UNITED STATES PATENT AND TRADEMARK OFFICE

APPLICATION NO.	FILING DATE	FIRST NAMED INVENTOR	ATTORNEY DOCKET NO.	CONFIRMATION NO.
10/750,433	12/30/2003	Michael R. Clark	31419.23990	1979
26781	7590	05/09/2007	EXAMINER	
BROUSE MCDOWELL LPA 388 SOUTH MAIN STREET SUITE 500 AKRON, OH 44311			LUONG, VINH	
		ART UNIT	PAPER NUMBER	
		3682		
		MAIL DATE	DELIVERY MODE	
		05/09/2007	PAPER

Office Action Summary	Application No.	Applicant(s)	
	10/750,433	CLARK ET AL.	
	Examiner	Art Unit	
	Vinh T. Luong	3682

ATTACHMENT 1

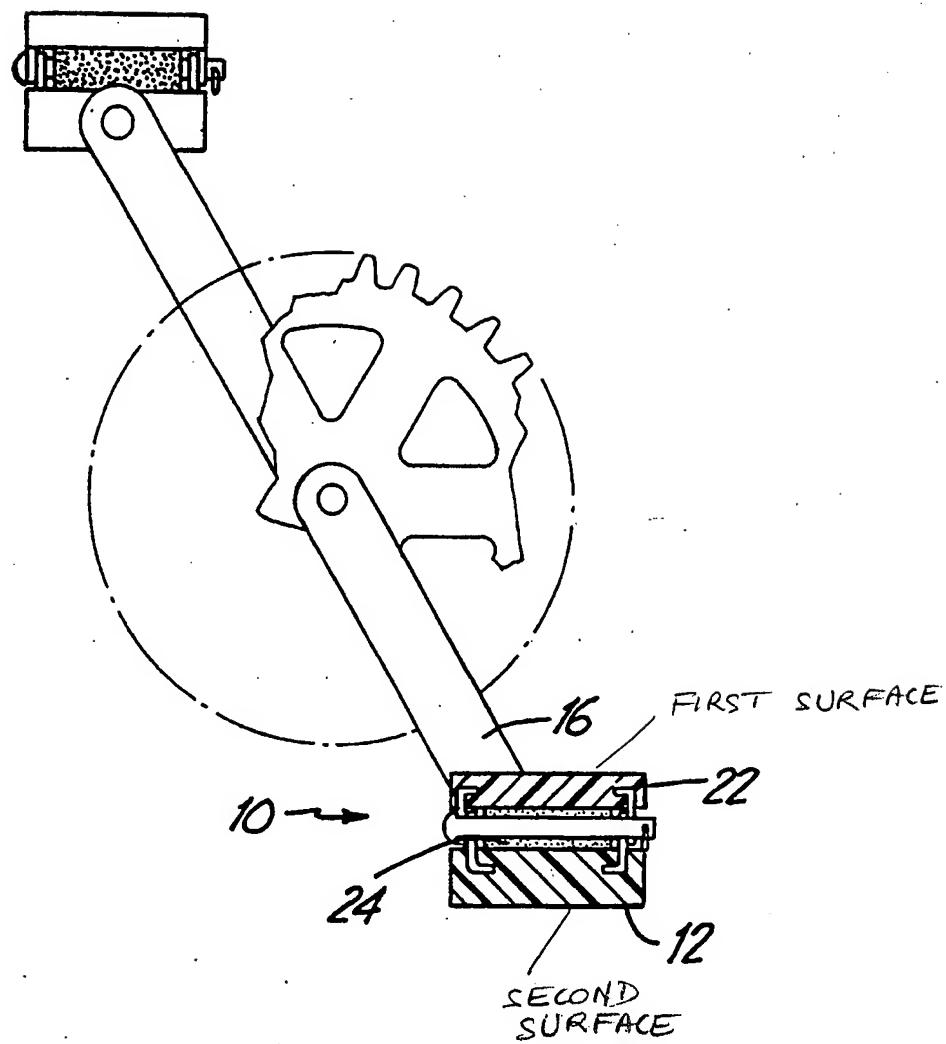
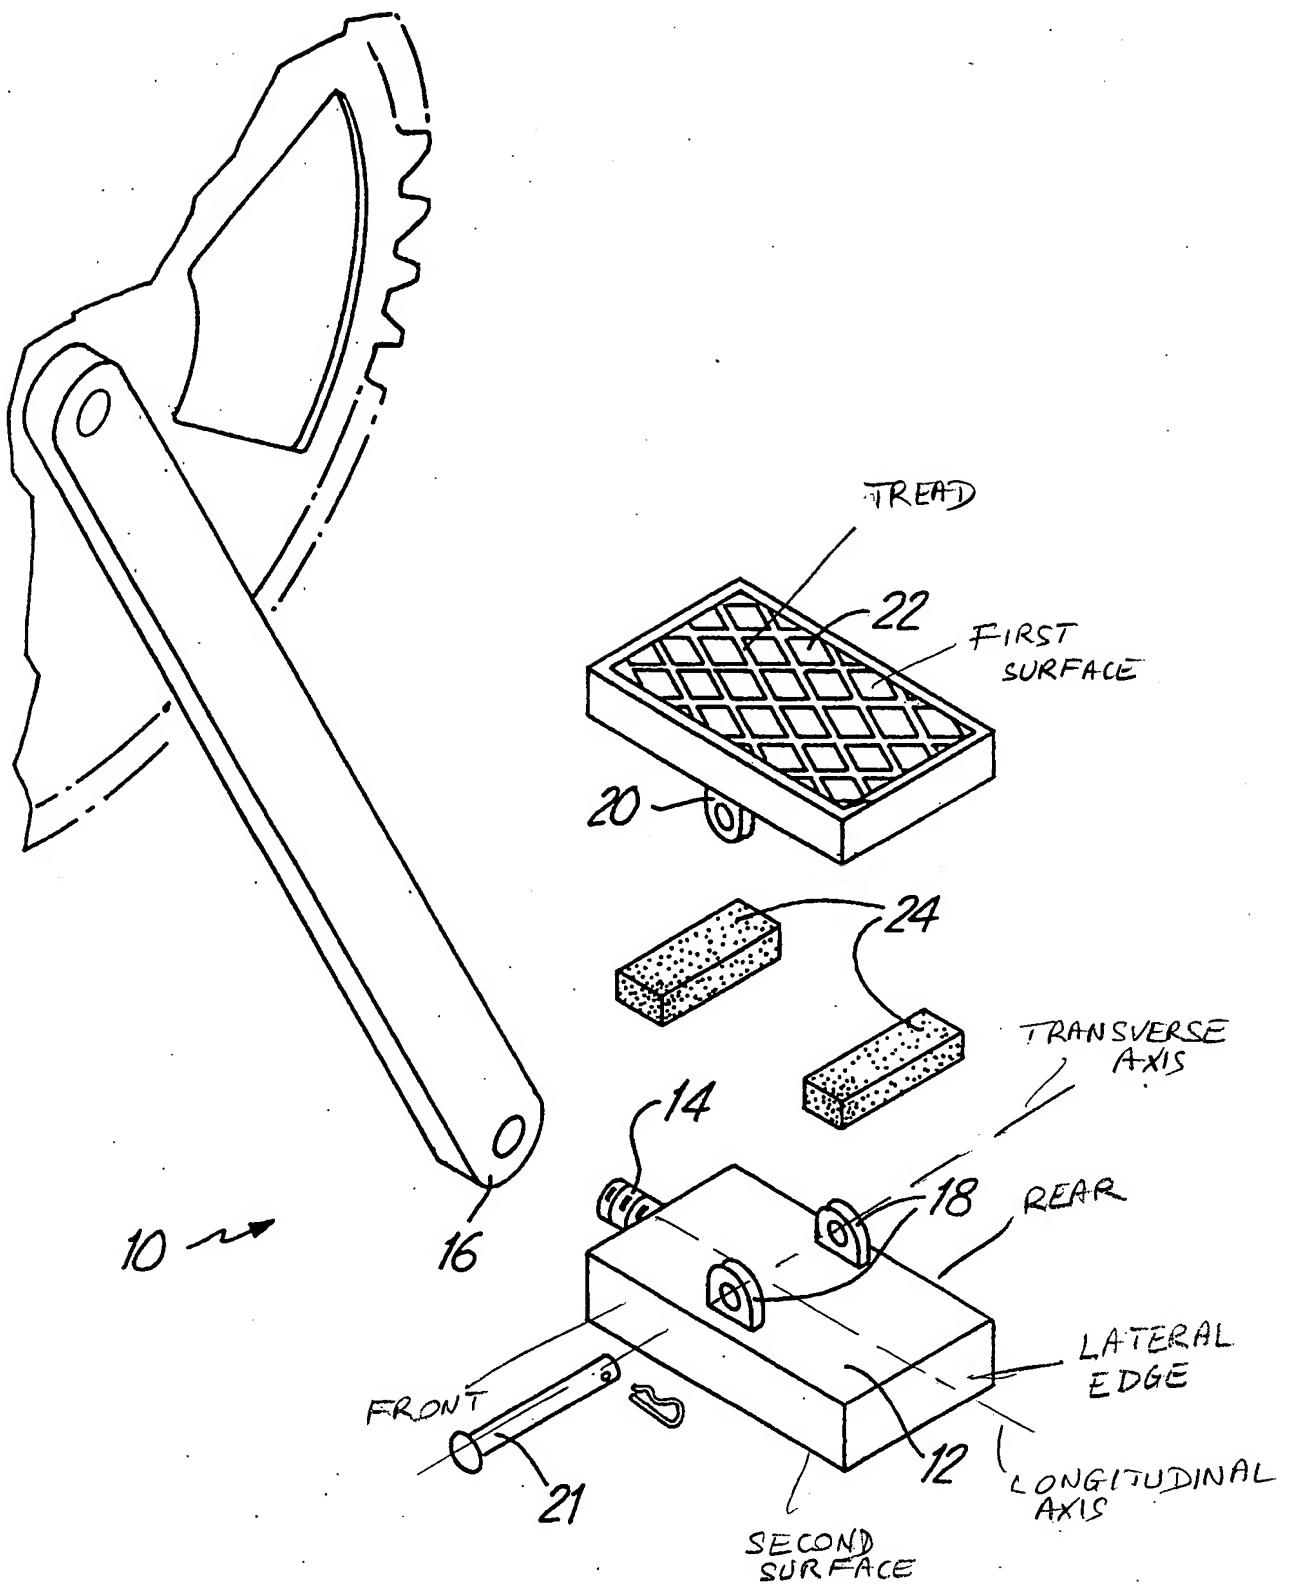
Hervig'332 teaches an apparatus 10 comprising a reversible pedal body 22, 12 having first and second surfaces 22 and 12 (see Attachment 1 hereinafter "Att. 1"), wherein said first surface 22 is adapted to contact an associated foot, said second surface 12 is adapted to contact an associated shoe, said pedal body 22, 12 having a front (Att. 1) oppositely disposed from a rear (Att. 1), said pedal body 22, 12 having first and second lateral edges (Att. 1) extending between said front and said rear, said pedal body 22, 12 having a longitudinal axis (Att. 1) and a transverse axis 21 (Att. 1), said pedal body 22, 12 being operatively connected to an associated exercise device (weight lifting equipment and bicycle), said pedal body 22, 12 further comprising a first weight 24 and a second weight 24 operatively connected to said pedal body 22, 12, such that one of said surfaces 22, 12 faces substantially upwards as said pedal body 22, 12 approaches an equilibrium position, said first and second weights 24 being oppositely disposed and substantially equidistant from said transverse axis 21 (FIG. 3).

Claim 1 is anticipated by Hervig'332 because Hervig'332 teaches each positively claimed element and its functional statement. On the one hand, Hervig'332's elements 24 inherently are subjected to the gravitational force of the earth. Therefore, they must have an amount or quantity of heaviness, i.e., mass or weight. Therefore, the elements 24 "read on" the claimed weights. On the other hand, it has long been held that the recitation that an element is "adapted to" perform a function is not a positive limitation but only requires the ability to so perform. It does not constitute a limitation in any patentable sense. *In re Hutchison*, 69 USPQ 138 (CCPA 1946).

Regarding claims 8 and 17, Hervig'332 teaches the tread on the first surface (Att. 1) in order to provide friction engagement. It would have been obvious to one having ordinary skill in the art at the time the invention was made to form the tread on Hervig'332's second surface in order to provide friction engagement as taught or suggested by Hervig'332. The use of tread to provide friction is notoriously well known in the art of bicycle pedal.

ATTACHMENT 2

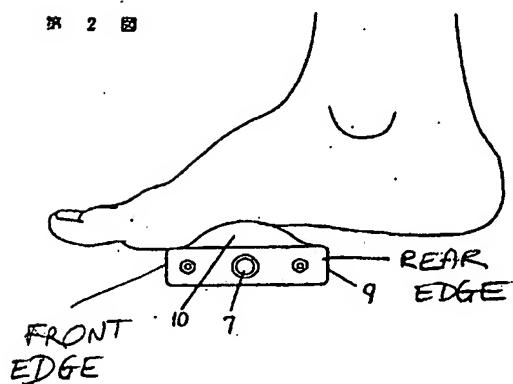
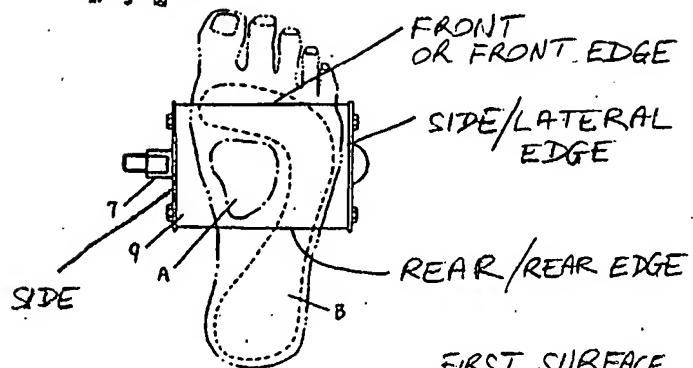
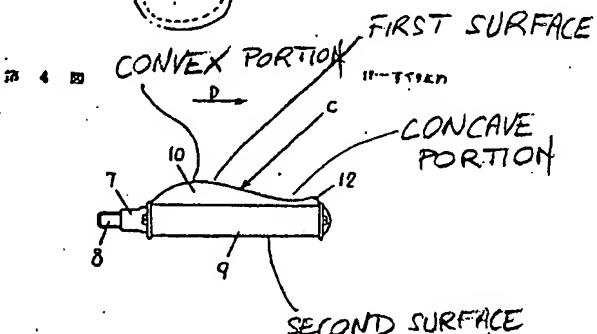
Regarding claim 3, Mitsuo's first surface comprises a concave portion (Att. 2) and a convex portion (Att. 2) so as to *substantially* conform to an arch A of a foot B. Mitsuo, abstract.

Regarding claim 4, Mitsuo's first surface (Att. 2) comprises a front edge *substantially* flush with said rear of said pedal body; and a rear edge *substantially* flush with said front of said pedal body 9, 10 as seen in Fig 2.

Regarding claim 5, Mitsuo's front edge (Att. 2) is left or right directional.

Regarding claim 13, Mitsuo's first surface further comprises a rear edge (Att. 2), said first surface (Att. 2) has a concave portion (Att. 2) transitioning into a convex portion (Att. 2).
